Note:  
Resistor and capacitor values shown are nominal values to implement transfer function shown. Values can be changed to implement different transfer functions in each section. If values are changed the overall gain of the circuit at DC must be 3 (9.54 dB).  
Designators shown in red correspond to designators used in component calculation spreadsheet.

Revision	Description of Change	Date
A	Initial release	5/00
A1	1. Added note about RevA1 upgrade board. 2. Changed R134, R135, R140, R141 to 3.01K	1/01
B	1. Added jumpers JbX to selectively jumper individual filter sections. 2. Added output buffer amps UbX to each channel. 3. All components added for Rev B have a "b" in the designator. 4. Removed output jumpers J1, J2, J4, J5, J6, J7, J8, J9. 5. Added test points for power connection.	3/01
B1/B2	1. Changed component values to have two sections w/ 2 ea butterworth poles at 30 Hz and 2 ea. butterworth zeros at 100 Hz to allow for easier lock acquisition of IFO.	4/01
B3	1. Changed AD829 to LT1128 or OP27 (Ub1, Ub2, Ub3, Ub4) 2. Changed components to make 2 poles @ 15Hz, 2 zeros @ 75Hz.	6/02
B4	1. Changed R4, R47, R108, R169 to 158K. 2. Changed C1, C37, C83, C116 to 10uF. 3. Changed

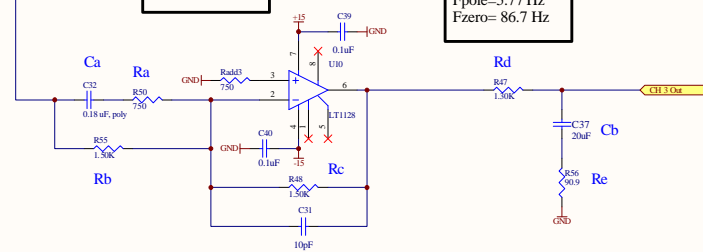
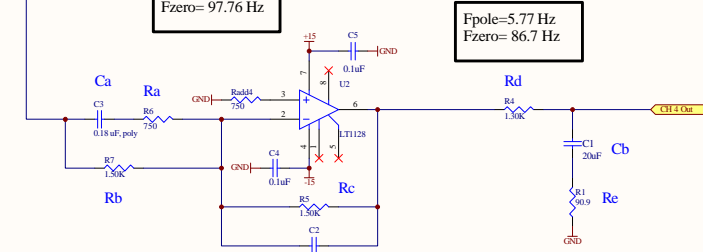
Fpole= 1180 Hz  
Fzero= 393 Hz

See Rev C8 Note

Fpole= 1223 Hz  
Fzero= 97.76 Hz

See Rev C8 Note

C8	1. Values changed to give Rev A1 transfer function with modified real pole and zero on output stage as shown. 2. Output op amp changed from AD829 to TLE2027 for stability. It may be an SO-8 package in a socket adapter. 3. All Rev B notes apply to Rev C schematics.	9/03
